Wollongong Local Planning Panel Assessment Report | 5 December 2018

WLPP No.	Item No. 3
DA No.	DA-2018/653
Proposal	Demolition of existing structures and construction of residential flat building comprising 22 units over five (5) storeys and one (1) level of basement parking
Property	29 and 31 Virginia Street, North Wollongong
Applicant	ADM Architects
Responsible Team	Development Assessment and Certification - City Centre Team (RW)

ASSESSMENT REPORT AND RECOMMENDATION

Figure 4: Revised L5 layout with additional balconies highlighted

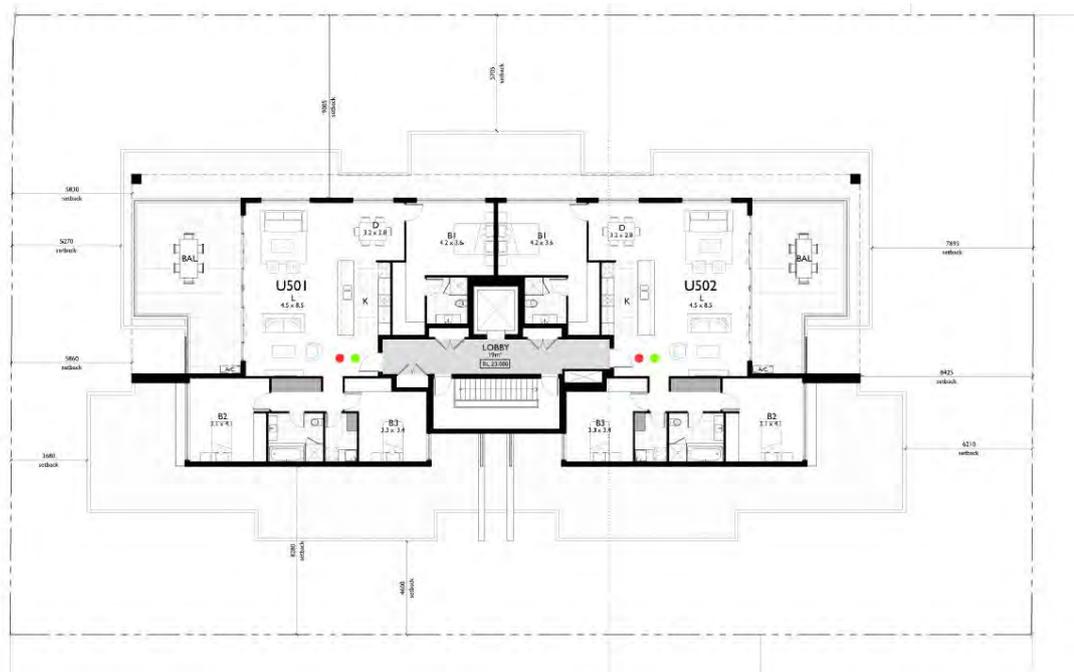
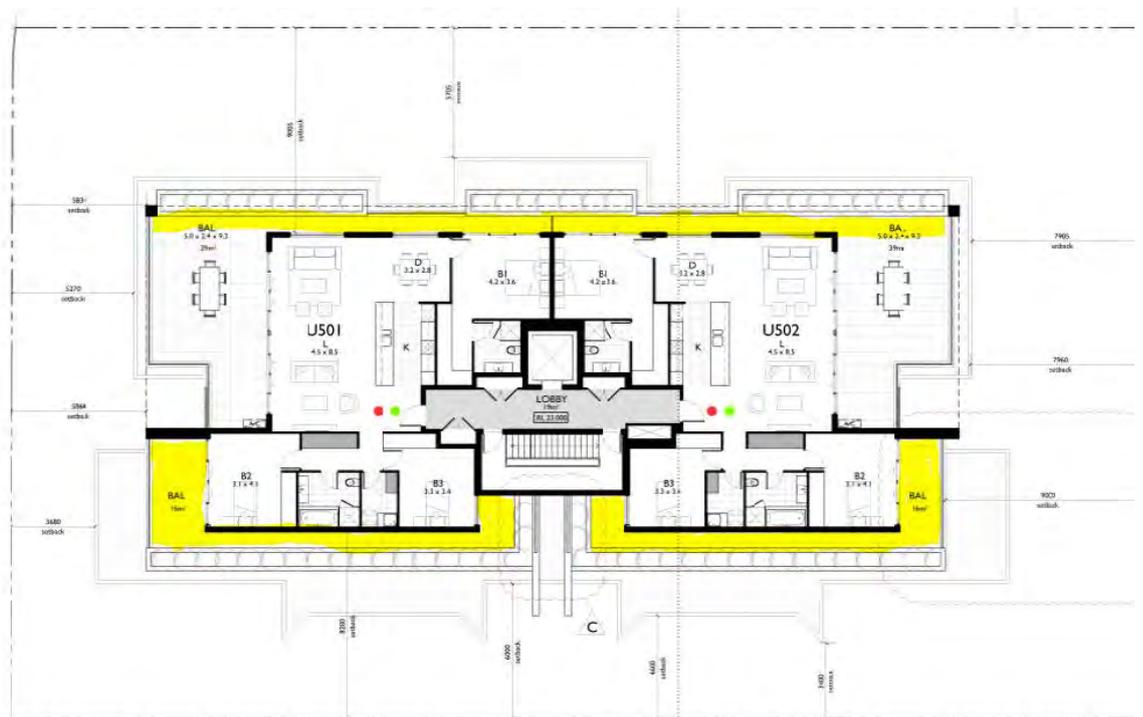
- *Reduce perceived height of building through planting at building edge on Level 5*

Response: Landscaping is proposed on the northern and southern elevations. DRP recommended the flat roof areas be landscaped for a planted green edge with access to these areas being for maintenance purposes only. This has largely been achieved, however the balcony areas adjacent to 'B3' slightly exceed the area required purely for maintenance and a condition is recommended for these areas to have a maximum trafficable width of 1m to limit the use of these balcony areas for maintenance purposes only.

Also, DRP noted that the balcony sitting areas are to be kept behind the 9m setback on corners. The revised Level 5 plan extends the sitting areas of both U501 and U502's balconies so that they encroach into the 9m balcony setback (by 1m). Given this is adjacent to planter beds, no significant

amenity or visual impacts are anticipated and the revised plans are considered to be consistent with the intent of the DRP advice.
